Campbell Mountain Landfill Leachate Management

Addendum No. 2

To: Posted on BC Bid Website
ITT: RDOS-21-ENG-10
Attachments: Addendum #2

Attachment #1: Drawing Details F and G

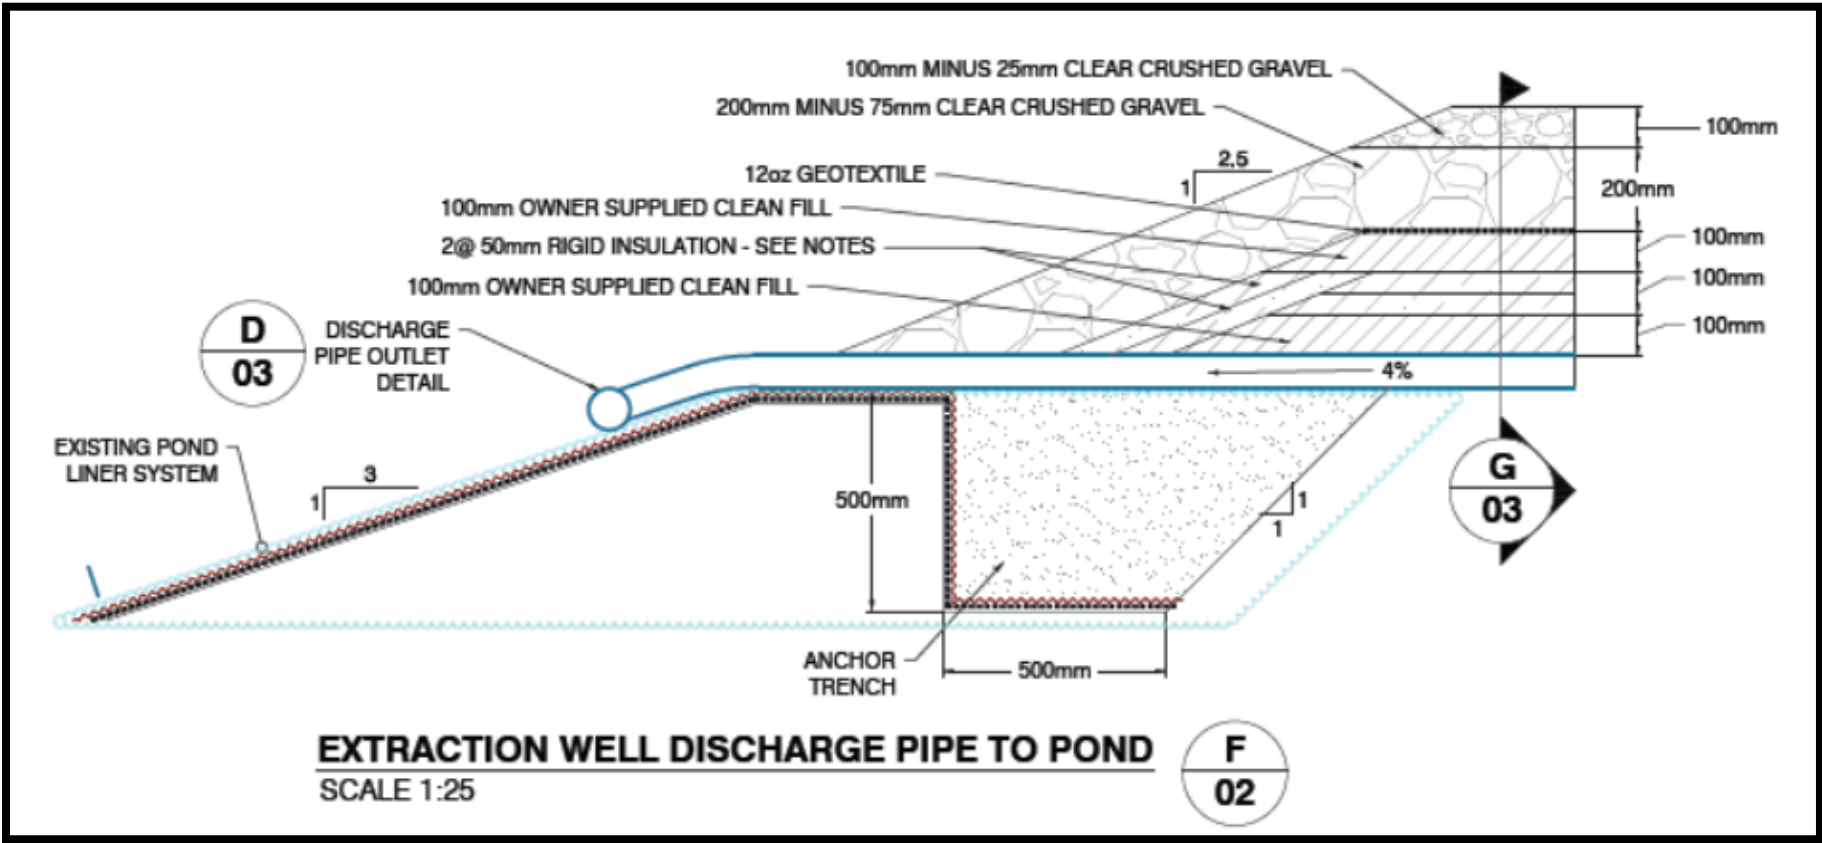
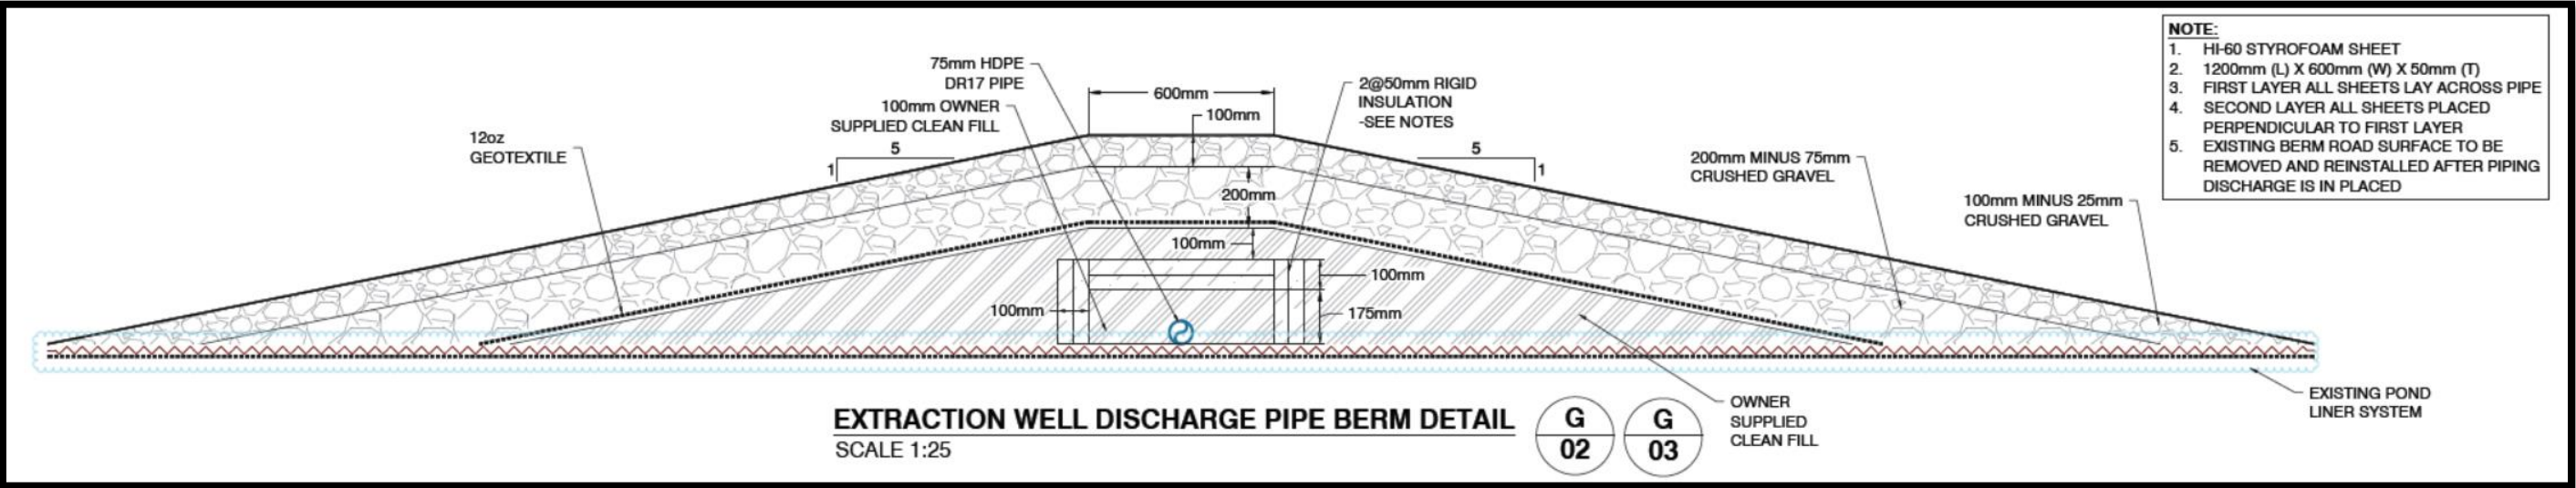
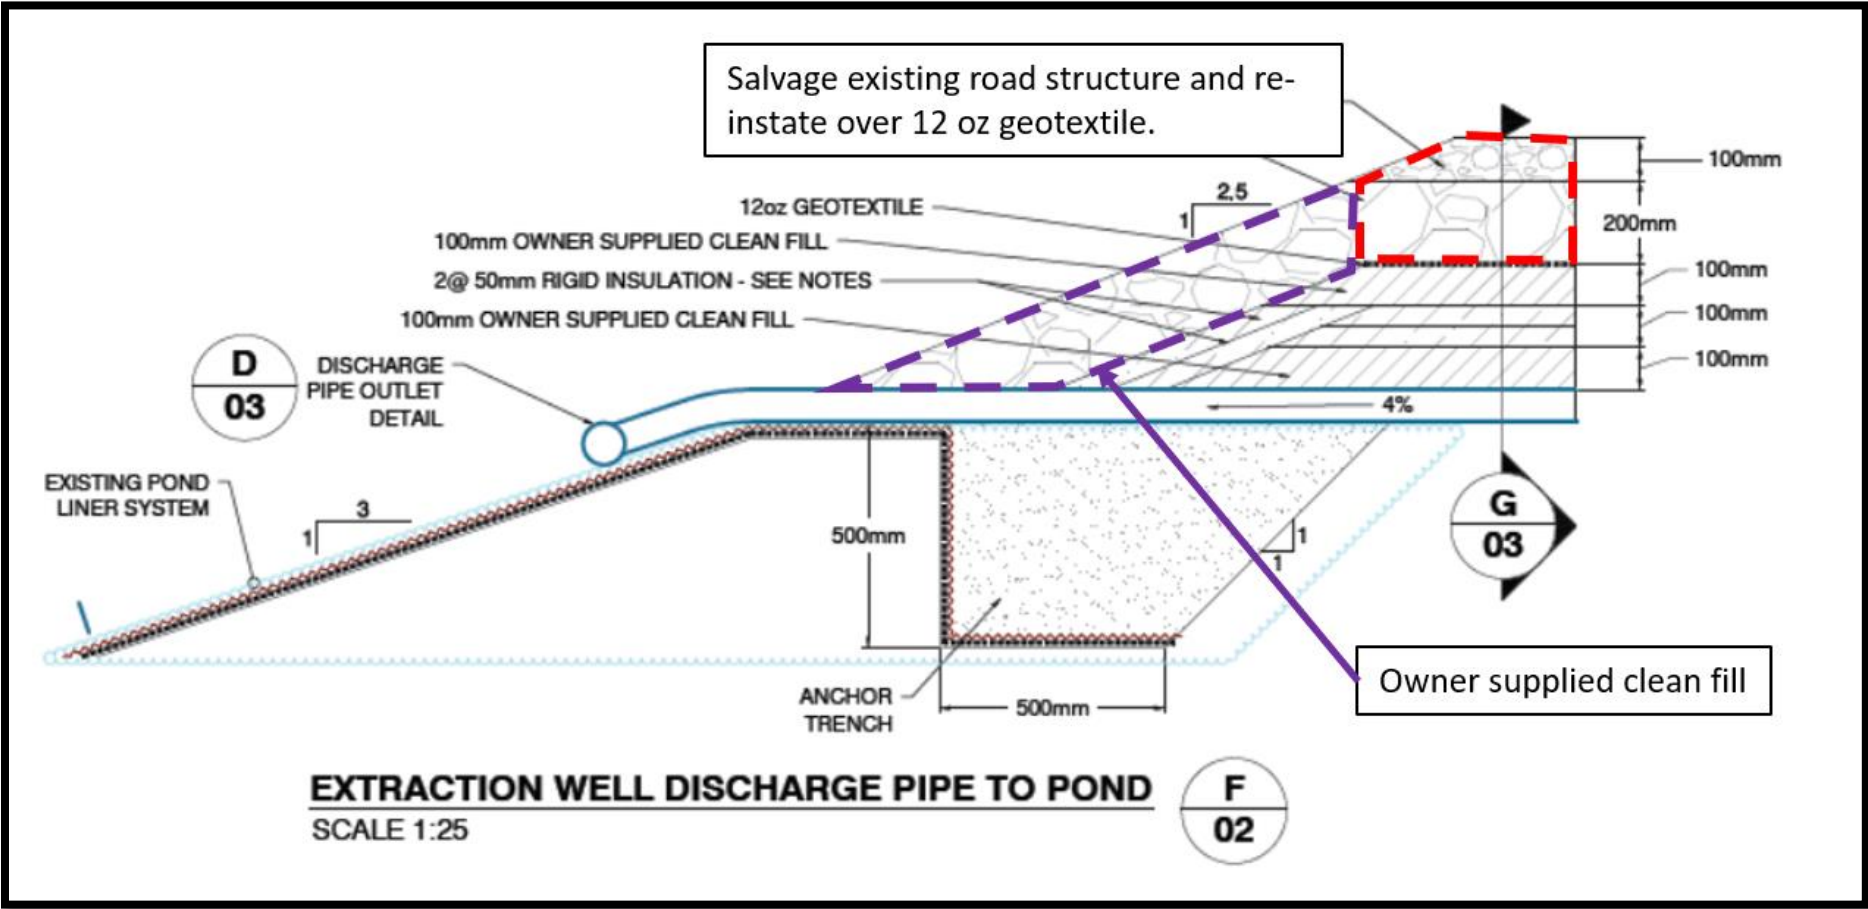
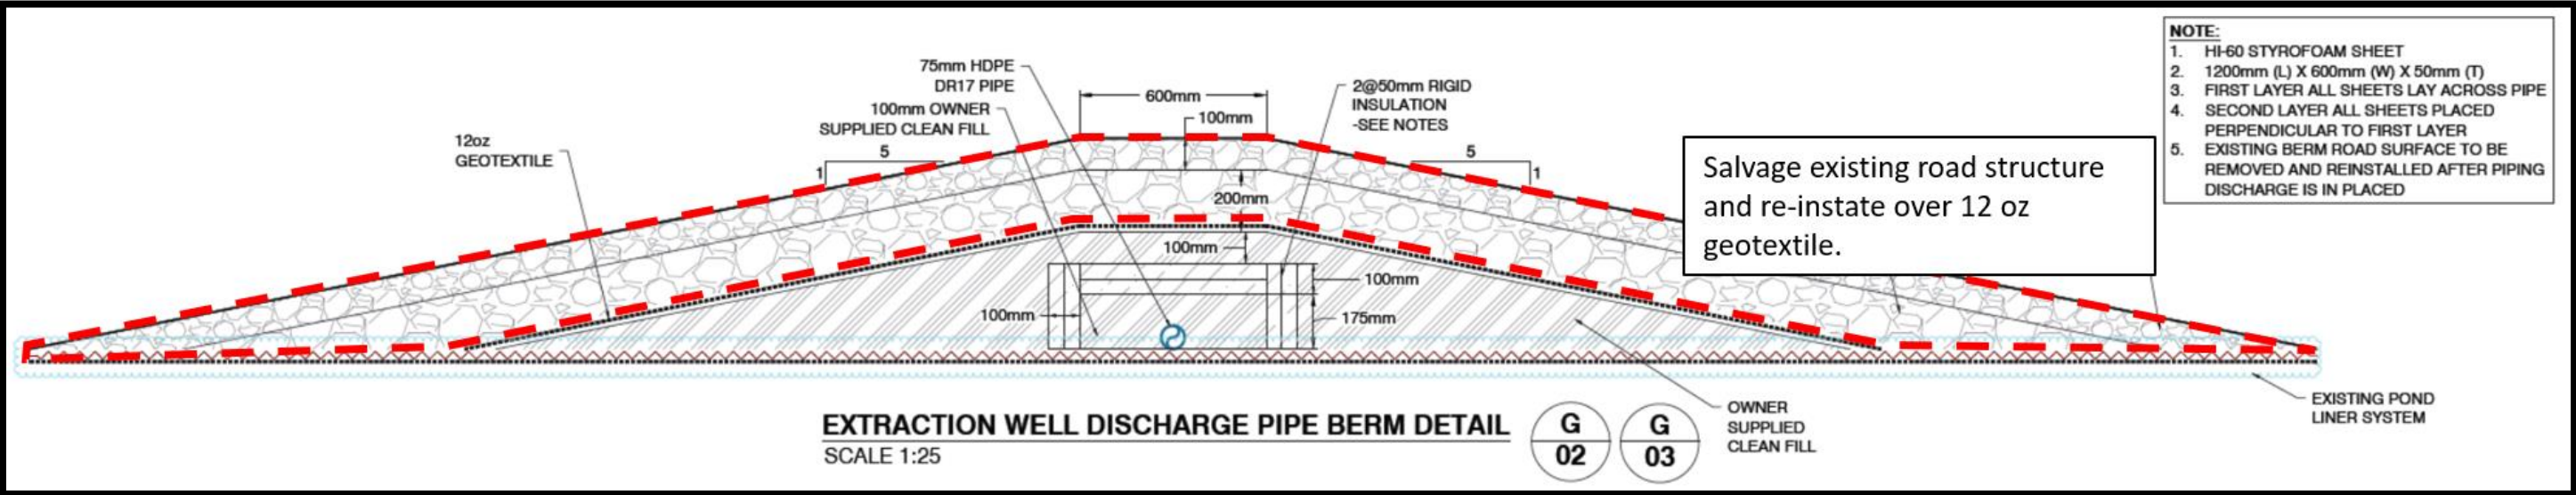
1. General information from the Bidders Meeting:
 - a. RDOS is responsible for the verification of clean fill as an owner supplied product.
 - b. Contractor to provide a site trailer for contractor use if deemed necessary. It is not a requirement.
 - c. Owner supplied clean fill will be placed beside the common utility trench as coordinated by the prime contractor with a minimum of 48-hour notice.
 - d. Gates must be shut outside of operating hours. Prime contractor to coordinate with RDOS for site key to work outside of operational hours, as per RDOS conditions and acceptance.
2. Drawing Detail E has been modified. The existing road structure is required to be salvaged and re-instated over the 12 oz geotextile. If additional road aggregate is required, RDOS will supply additional material. See Attachment #1: Detail F and G for more details.

Q11: Owner supplying any other materials other than the "Supplied Clean Fill"?

- b. Payment: Linear Meter (m)
- c. Includes: All labour, equipment, materials and all other incidental work required to supply and install the leachate discharge structure in the road area, as shown in Detail F & G: Extraction Well Discharge Pipe Berm Detail and all other relevant details, as shown in the contract Drawings. Also include, excavation in existing soils, and/or imported soils of all gradations and composition including cobbles and boulders less than the trench width. Also includes excavation for the range of trench widths and depths as shown on the Drawings. Also includes placing and compacting embedment and backfill material to be owner supplied clean fill, and salvage road structure to be re-instated over the 12 oz geotextile, as shown on the drawings. Additional road structure will be provided by RDOS if necessary.

A11: See modified pond discharge structure sketch in Attachment #1.

SS Check Valve and Yard Hydrant

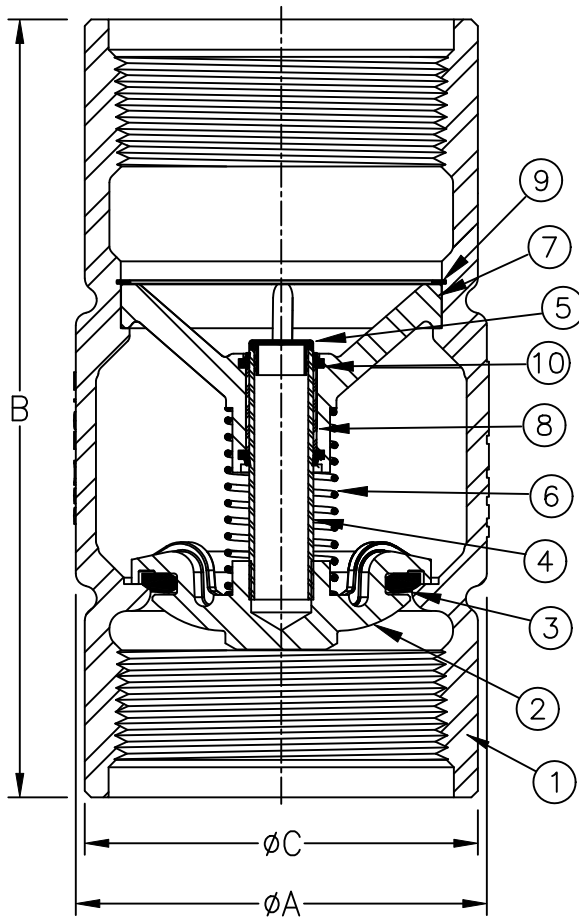
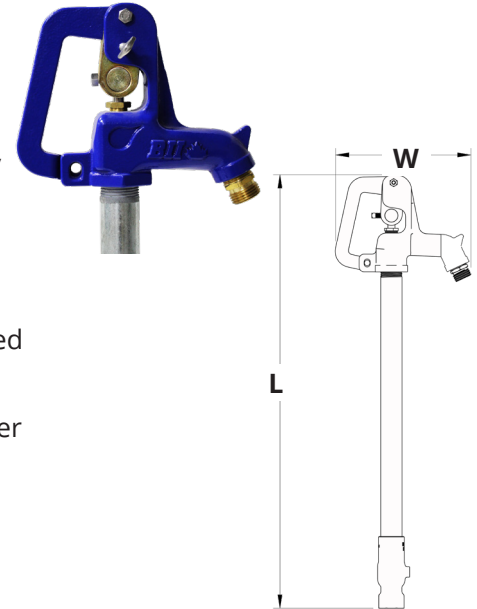
- Q8: What are the requirements for the SS check valve and yard hydrant?**
- A8: The proposed materials as shown in Attachment #3 are acceptable. Contractor is required to confirm field requirements for layout, depths, and hardware compatibility.
